PLANT NAME: KEWAUNEE

Docket 50-305
Operating License DPR-43
Response to Request for Additional Information and
Staff Positions Concerning Fire Hazards Analysis

ENCLOSURE 1

ENCLOSURE 2

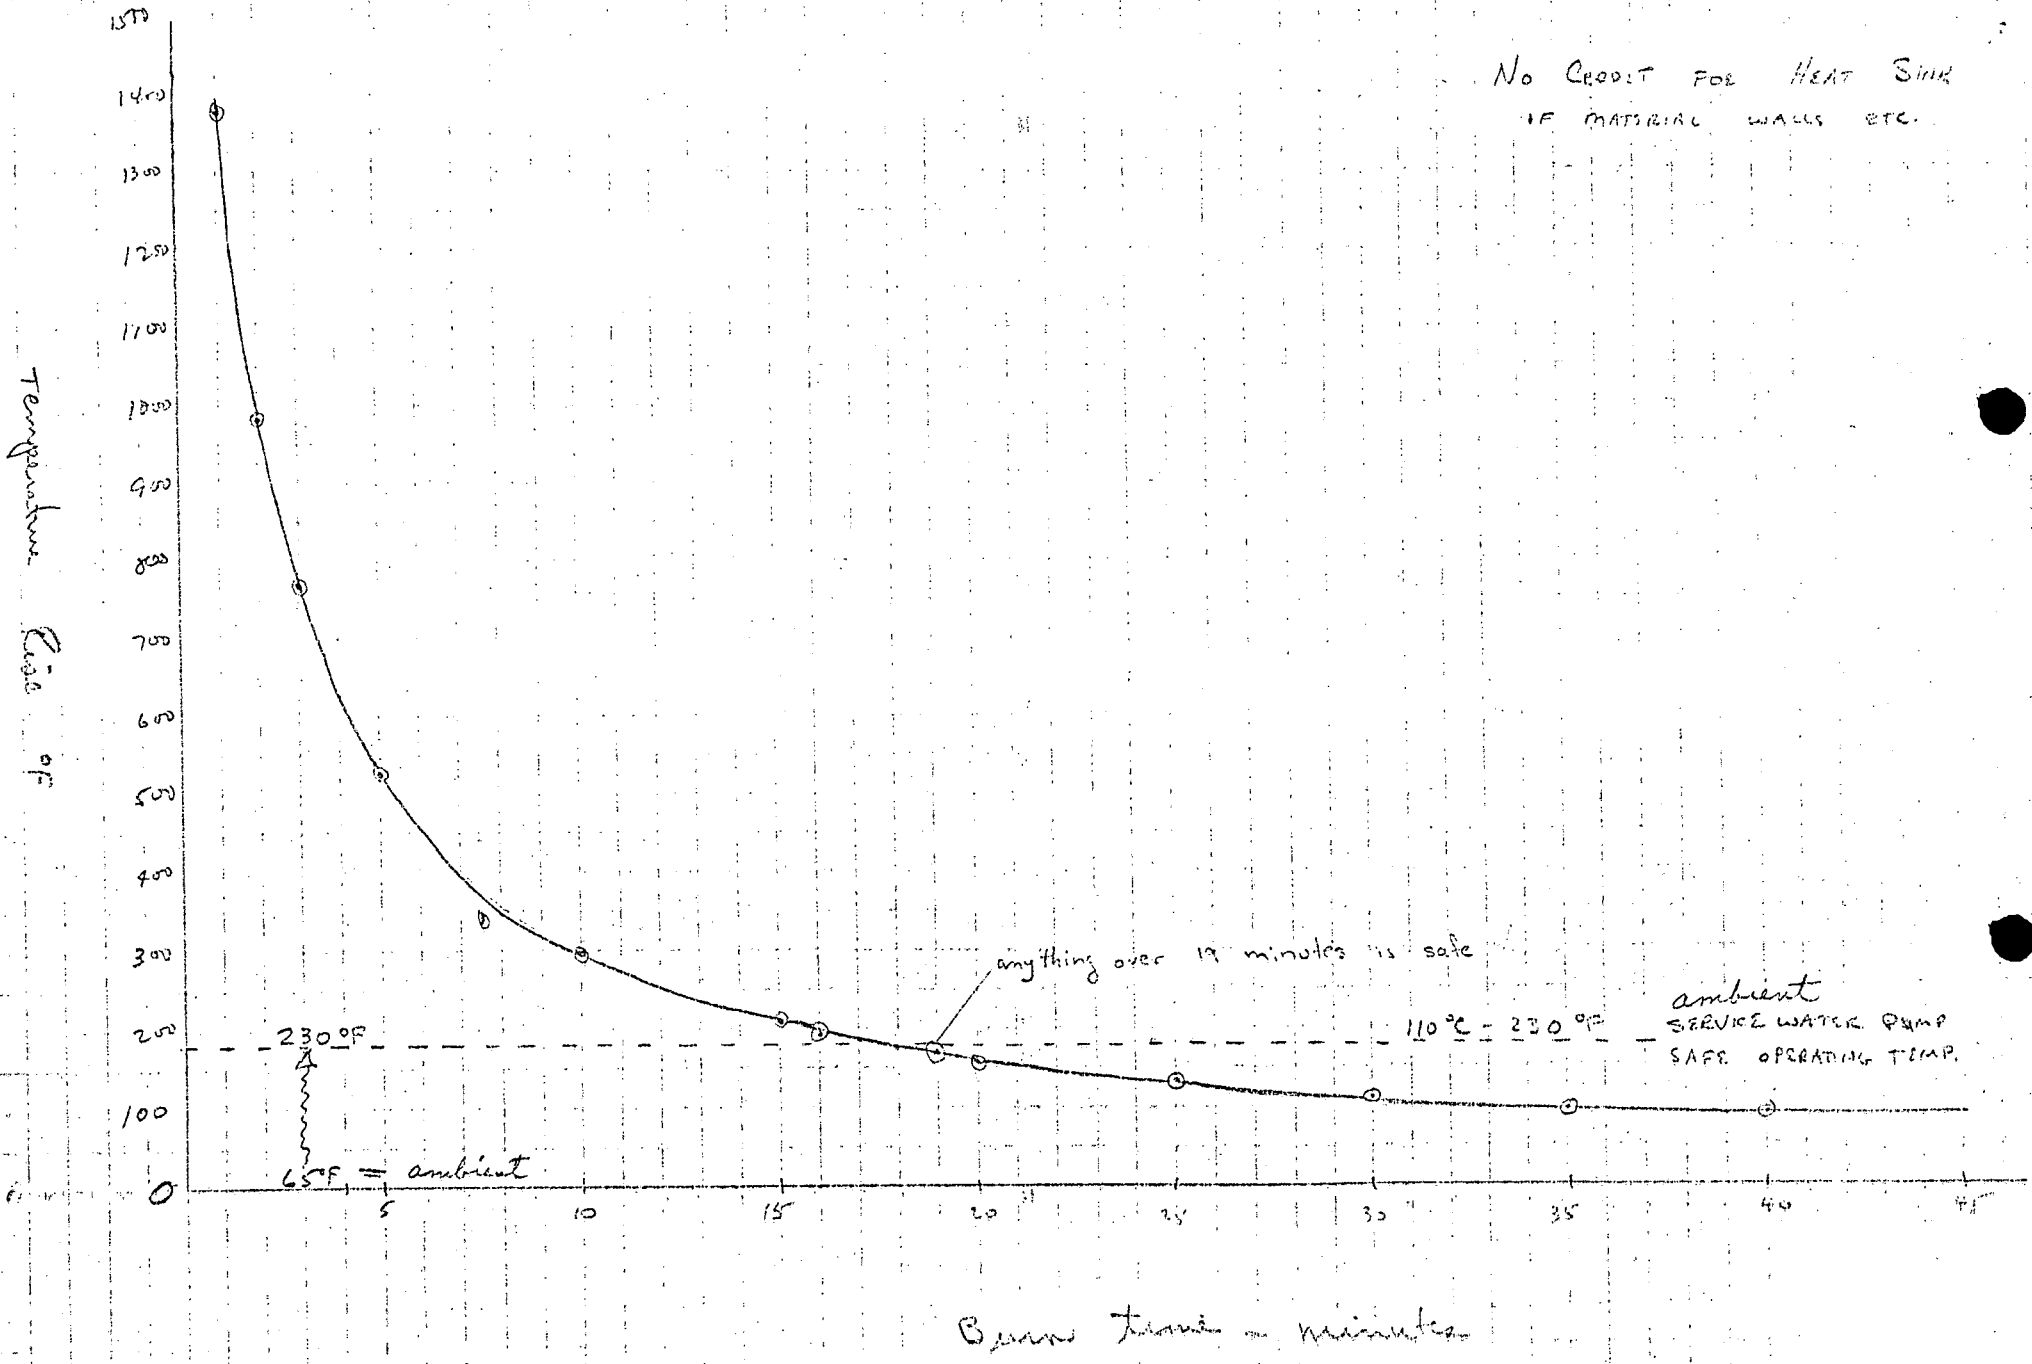
P31. To preclude loss of service water pumps and fire pumps due to a fire involving the circulating water pump lube oil, automatic sprinkler or water spray system providing coverage of the circulating water pumps should be provided or an analysis must be provided which shows that heat buildup in the area of the service water pumps will not result in temperatures greater than the ambient temperature rating for the service water pumps. In this regard the assumptions used for any such analysis must be stated and justified (e.g., burning rate, pool size, air flow distribution, initiation and maintenance of ventilation, etc.).

P31. RESPONSE: Attached you will find our calculations for the temperature rise in the greenhouse. Part 1 of the calculation determines the temperature rise given varying burn times. The BTU input from the burning oil is fixed; the longer it takes to burn, the lower the temperature buildup will be due to the change of air. The calculation is conservative in that it assumes the BTUs added per minute are not removed and discarded to the atmosphere, but rather remain and are added to incoming air at the rate the fans add additional air. The results of this calculation show a plot of temperature versus burn time that approaches zero temperature change as burn time increases.

The second part of the calculation is performed to establish the burn time of this oil fire.

It is assumed that the pool first fills with oil and then is ignited (worst case). Depth of pool is 1.238 inches. The burning rate in depth per time of oil is considered to be less than 3 in/hr. This is derived from data from the Fire Protection Handbook which shows the more volatile substances like gasoline to have a 10 to 12 in/hr. burning rate and kerosine to have a 5 to 8 in/hr. burning rate. At 3 in/hr. or 24.75 min. burn time ambient temperature would reach 195⁰ F. If we were to utilize the data from some combustion notes supplied by members of your staff, a burning rate of 9 in/hr., a burn time of 8.25 min. and an ambient temperature rise of 340⁰ F would be reached. However, this data does not appear applicable since it disagrees with typical burning rate data from more up to date sources. We consider the 3 in/hr. a conservative estimate of the burn rate of oil. A best estimate which employs deriving the ratio of the burning rate curve of kerosine to oil supplied by the staff's notes and the exact burning rate of kerosine yields a burning rate of 1.875 in/hr., a burn time of 39.6 min. and an ambient temperature rise of about 85⁰ F. It should be stressed that these numbers are conservative due to the method of calculation and the results

P31. RESPONSE (cont.): are being compared to an ambient operational long term limit. We know that the Service Water Pump motors and Exhaust Fan motors will continue to operate in higher temperatures with no abnormal effects for a period of time.

Air flow distribution has been considered uniform. For any intense short term fire this surely would be representative of the actual conditions. For long term burning and low temperatures there may be air streaming. If so, the hottest temperatures would be immediately above the fire at the roof and would be directly exhausted by the fans. Hence, the consequences would be minimized by this streaming affect. In conclusion, we have shown that even using conservative estimates, a circulating water pump oil fire would not jeopardize the operation of the Service Water Pumps.
